# Comments on “TDECQ updates”

IEEE P802.3cd March Plenary; 5 March 2018; Rosemont, IL

## ❑ Comments on king\_3cd\_01\_0318

## Recap from Slide #6-7

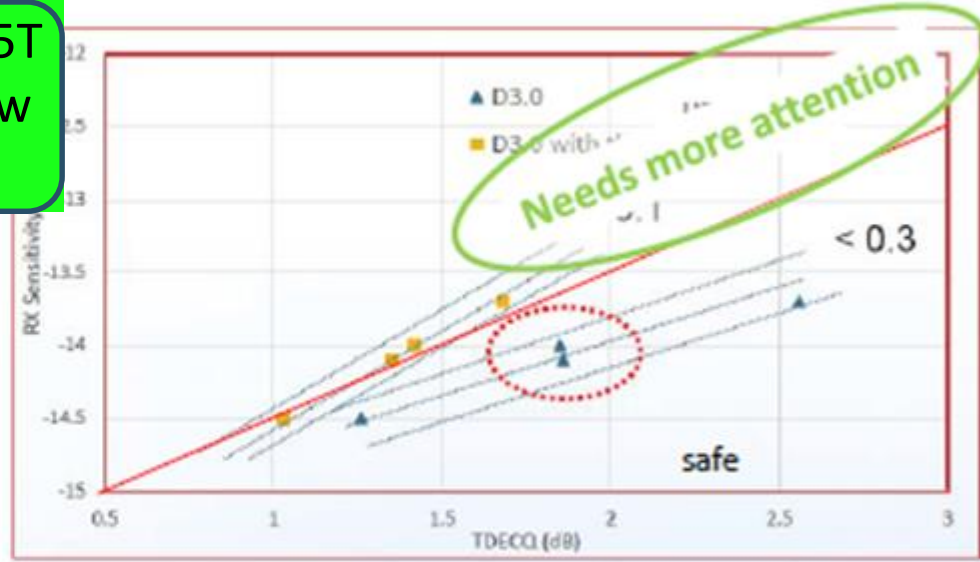
- When threshold slope of Rx sensitivity vs TDECQ is  $\leq 1$ 
  - This really would be a hole in the spec
- i.e. TDECQ with threshold adjustment underestimates receiver penalty, even though the receiver used has a much longer EQ (10 tap FFE) than the reference EQ
- In contrast, a reference EQ which is representative of the worst case receiver should tend to over-estimate sensitivity penalty (slope of receiver sensitivity vs TDECQ should be  $\leq 1$ )

king\_3cd\_01\_0318 make big deal on this plot, but NO actually 1:1 linear fit was done, so the conclusion could be misleading.

## Slide #6-7

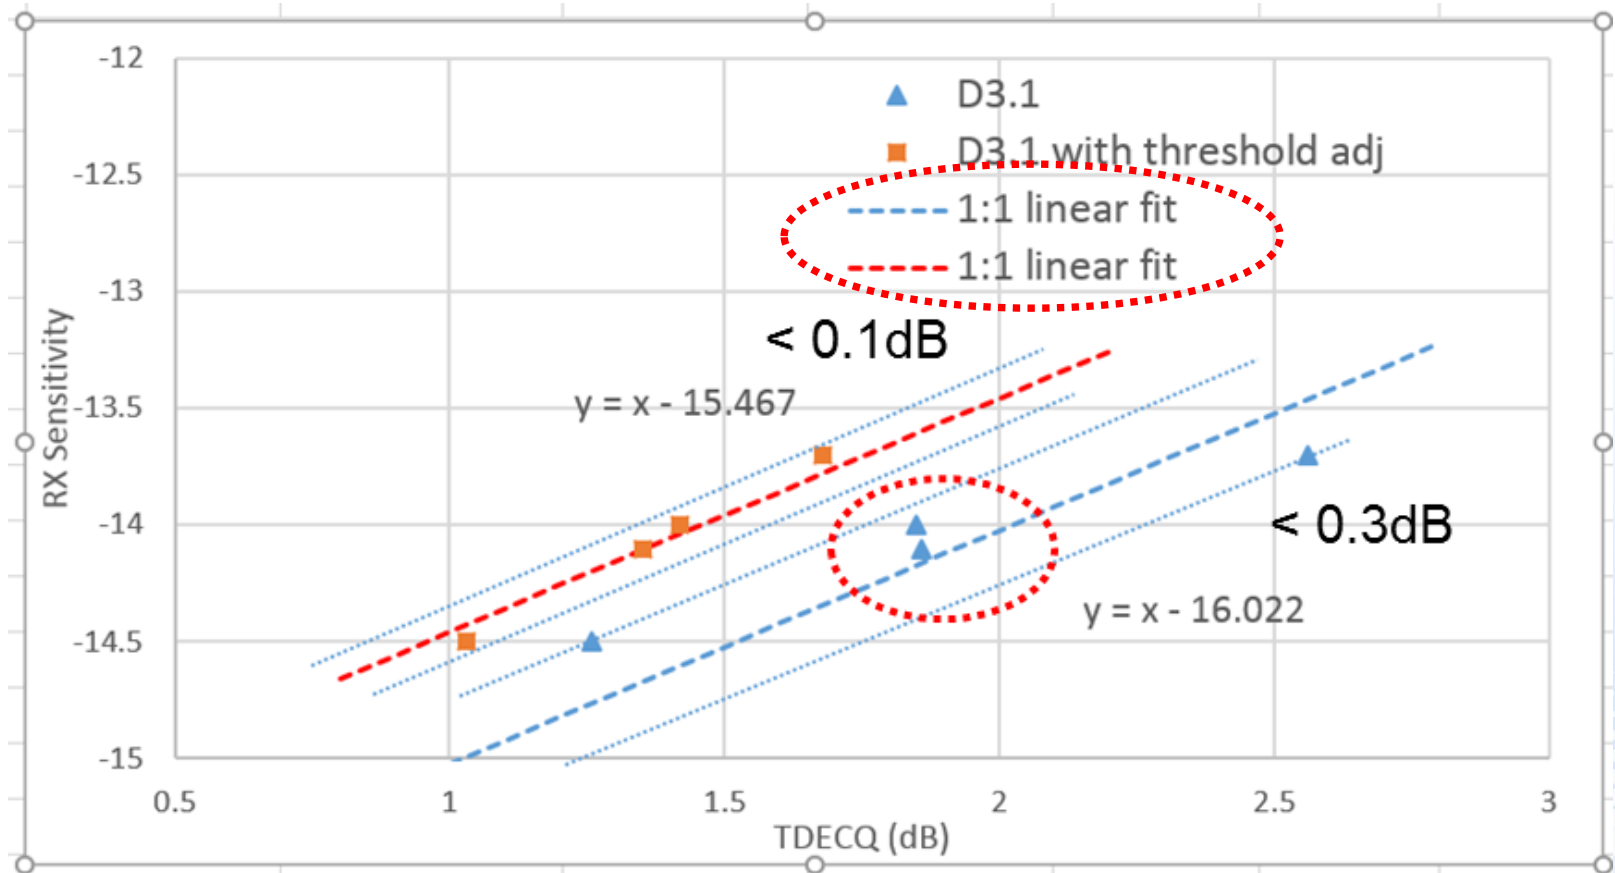
- Threshold adjustment obviously gives a better 1:1 linear fit than fixed thresholds.

Slide #9-10

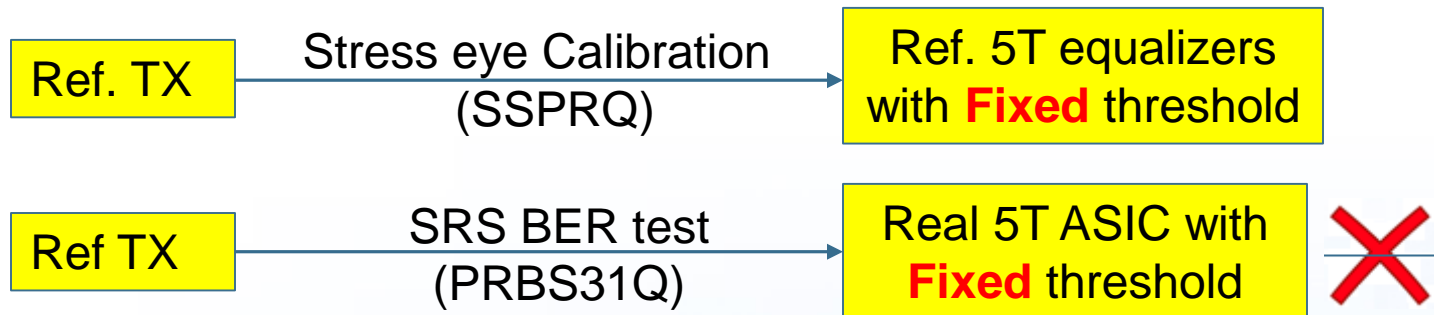
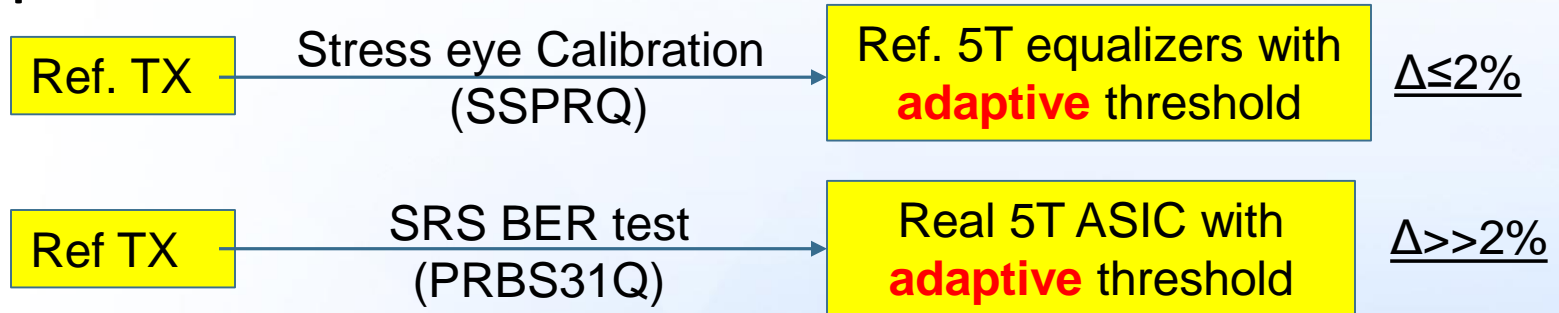
If the reference receiver has less threshold adjustment range than real receiver, then the receiver performance and yield is not going to be impacted

# 50G-PAM4 BER For Low And High TDECQ Tx

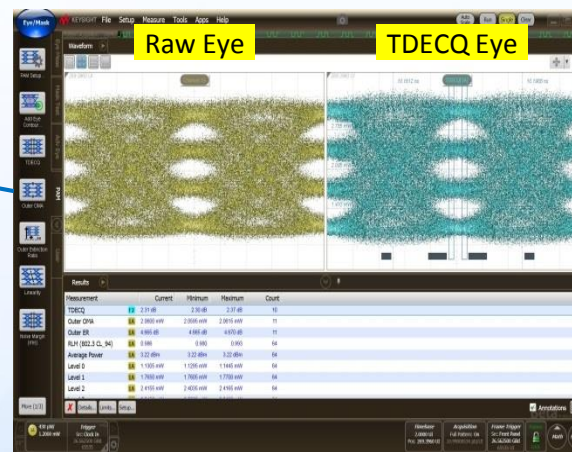
1. Measurements of 50G-PAM4 BER suggest Rx Sensitivity specifications for 50GBASE-FR and -LR have spare margin.
2. Reasonable to increase margin of Tx TDECQ by allowing small amount of threshold adjustment, which will help Tx yield.

# TDECQ Versus Threshold Adjustment For Low And High TDECQ Tx

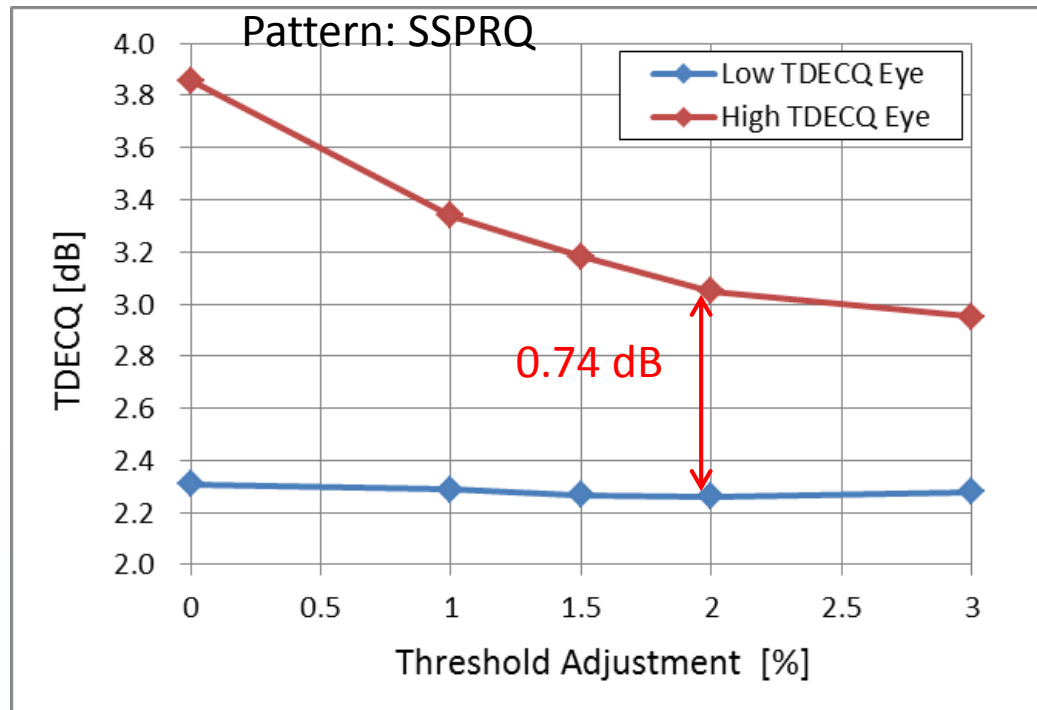
1.  $\Delta$ TDECQ without threshold adjustment (i.e. 0%) overestimates  $\Delta$ Rx Sensitivity at  $2.4E-4$  BER  $\rightarrow \Delta$ TDECQ = 1.6 dB corresponded to  $\Delta$ Rx Sensitivity = 0.74 dB ( $\Delta$  is difference between low and high TDECQ Tx measurements).
2. Threshold adjustment lowers TDECQ of high TDECQ Tx and gives better correlation to Rx penalty.
3. At 2% threshold adjustment,  $\Delta$ TDECQ  $\simeq \Delta$ Rx Sensitivity.
